SUNDRY NOTICES AND REPORTS ON WELLS
Do not use this form for proposals to drill or to re-enter an abandoned well. Use Form 3160-3 (APD) for such proposals.

1. Type of Well <input type="checkbox"/> Oil Well <input checked="" type="checkbox"/> Gas Well <input type="checkbox"/> Other		7. If Unit of CA/Agreement, Name and/or No.
2. Name of Operator Primero Operating, Inc.		8. Well Name and No. Apache Springs Fed #1
3a. Address PO box 1433, Roswell, NM 88202-1433	3b. Phone No. (include area code) 575 622 1001	9. API Well No. 30-005-21152
4. Location of Well (Footage, Sec., T., R., M., or Survey Description) 1442' FNL & 2174' FWL, Section 34, T10S, R30E		10. Field and Pool or Exploratory Area Wildcat
		11. County or Parish, State Chaves, NM

WELL BORE DIAGRAM

**Apache Springs Fed 1
30-005-21152
Primero Operating, Inc.
October 31, 2018
Conditions of Approval**

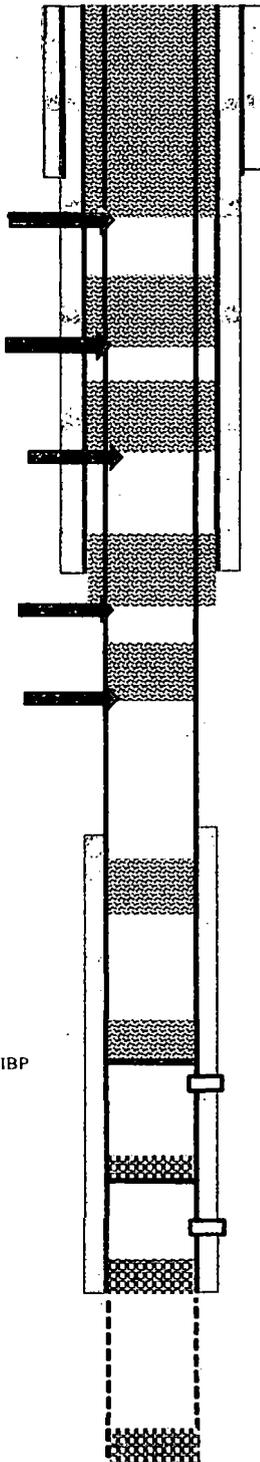
Plug 5 50 sx class C *1655'*
Tag <~~1605~~¹⁶⁵⁵
Perf 1700'

1. Operator shall place CIBP at 7,540' (50'-100' above top most perf) and place 35' of Class H cement on top as proposed. WOC and TAG.
2. Operator shall place a balanced Class C cement plug from 6,700'-6,500' to seal the top of the Abo formation. WOC and TAG.

3. Operator shall perf and squeeze at 4,500'. Operator shall place a balanced Class C cement plug from 4,500'-4,350'. As no more than 3,000' between plugs in cased hole.

4. Operator shall perf and squeeze as proposed at 3,045'. Operator shall place a balanced Class C cement plug from 3,045'-2,945' to seal the 8-5/8" casing shoe. WOC and TAG.

5. Operator shall perf and squeeze at 1,700'. Operator shall place a balanced Class C cement plug from 1,700'-1,555' to seal the top of the Yates formation. WOC and TAG.

6. Operator shall perf and squeeze at 1,050'. Operator shall place a balanced Class C cement plug from 1,050'-900' to seal the top of the Salt formation. WOC and TAG.

7. Operator shall perf and squeeze as proposed at 455'. Operator shall place a balanced Class C cement plug from 455'-surface to seal the 13-3/8" casing shoe. WOC and TAG.
